## **Packet Guide**

**BAR MINUTES  
CITY OF CHARLOTTESVILLE  
BOARD OF ARCHITECTURAL REVIEW  
Regular Meeting  
July 20, 2021 – 5:00 PM  
Zoom Webinar**

## PROPOSED POOL - Site Plan

1835 University Circle

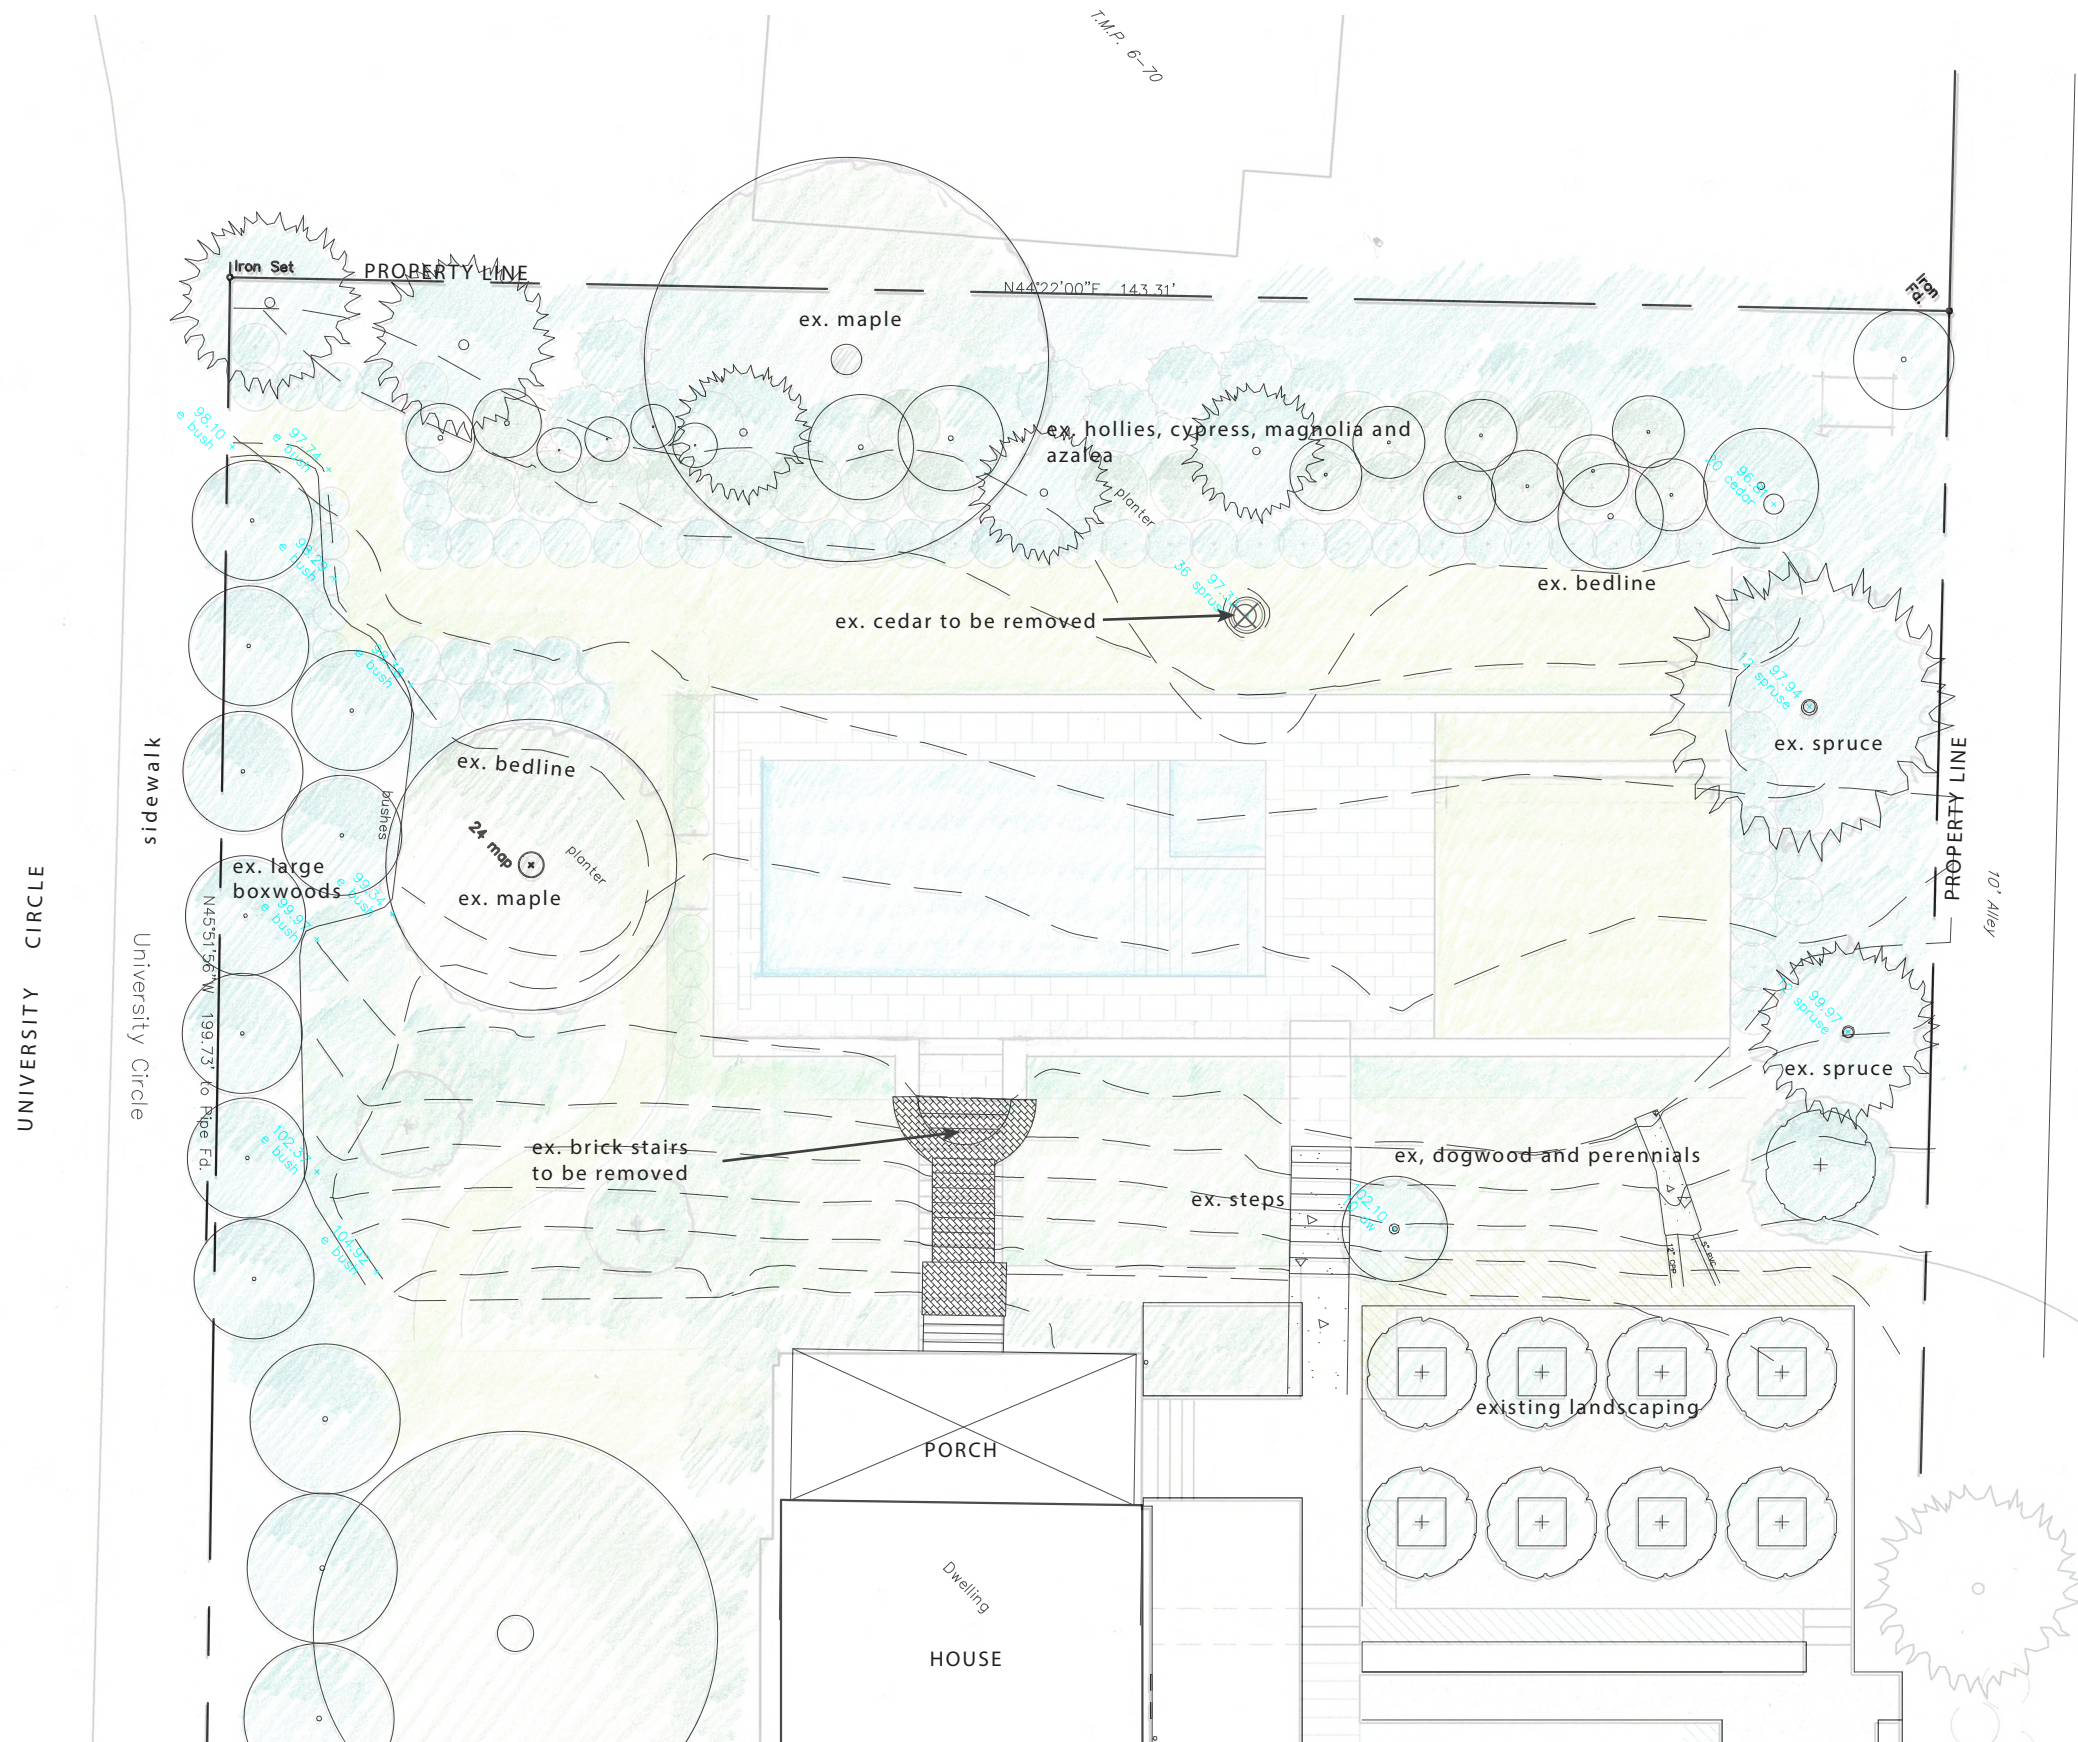
Staff finds that the material palette, scale, and proposed plantings of this landscape plan are consistent with other properties in the district. Based on the criteria in *Chapter II: Site Design and Elements* of the ADC District Design Guidelines, staff recommends approval, with a recommendation that the applicant consider adding an additional shade tree to compensate for the loss of the cedar tree.

Existing storefront

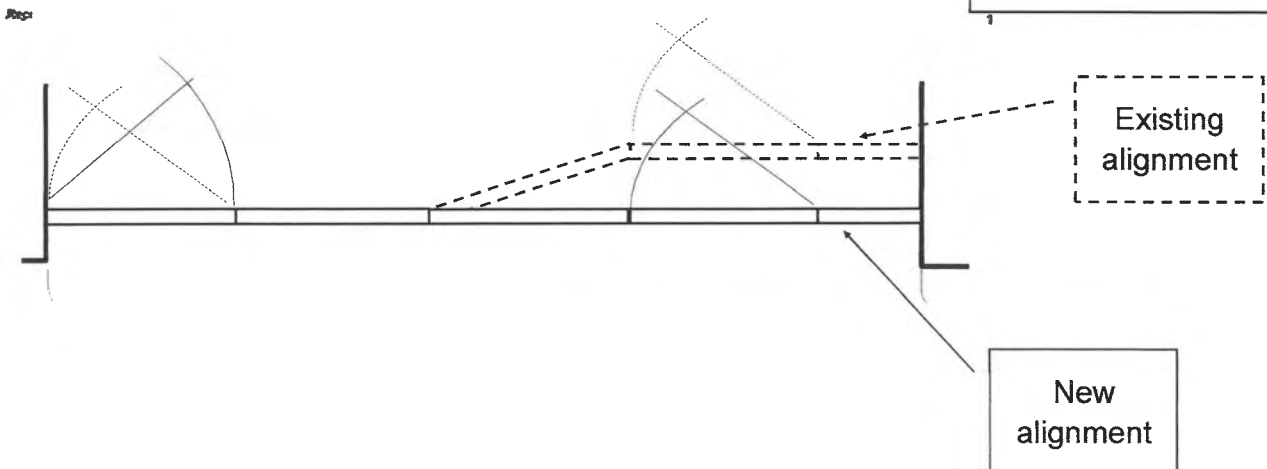
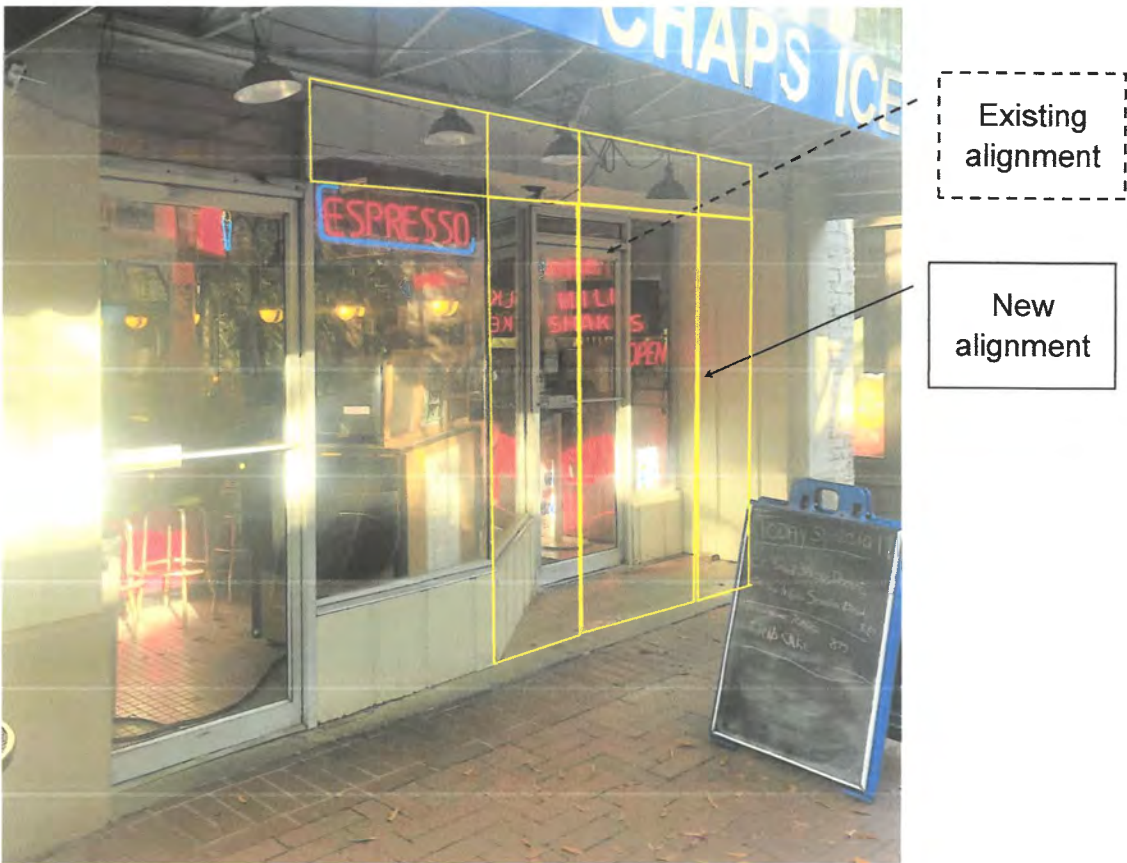
Replace plywood panels with flat, metal panels (to match frame)

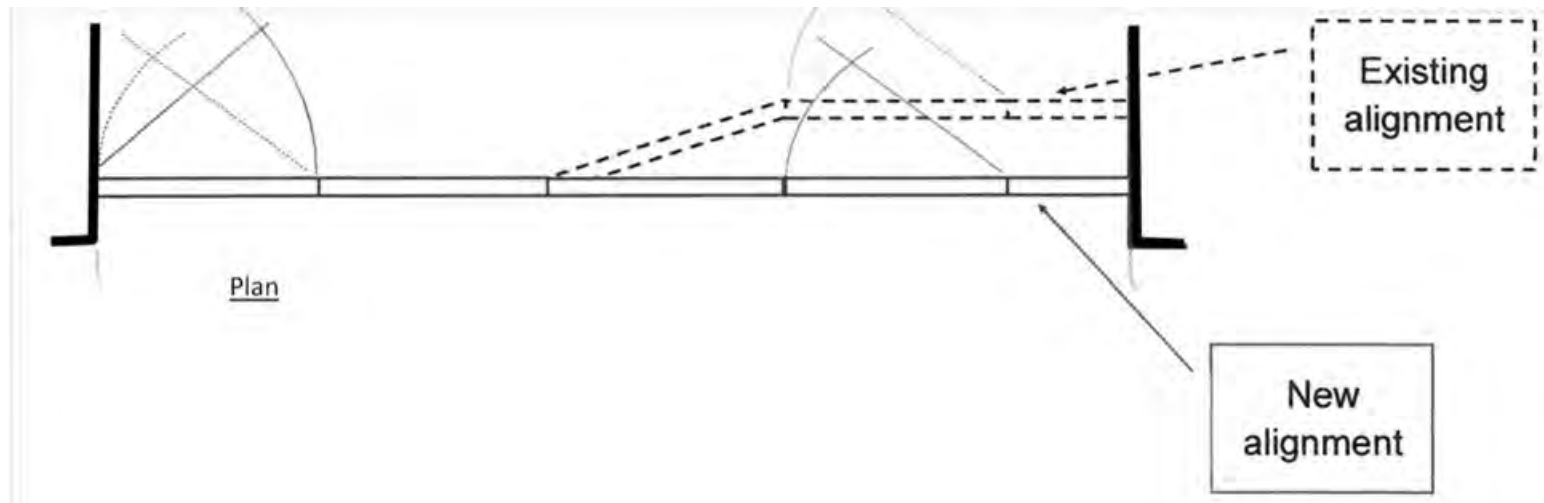
Need to confirm the layout and materials for the Chap's storefront. Sketch below based on what Tony shared with me back on 2020. Let me know if anything is different. We want to this approved by the BAR meeting next Tuesday.
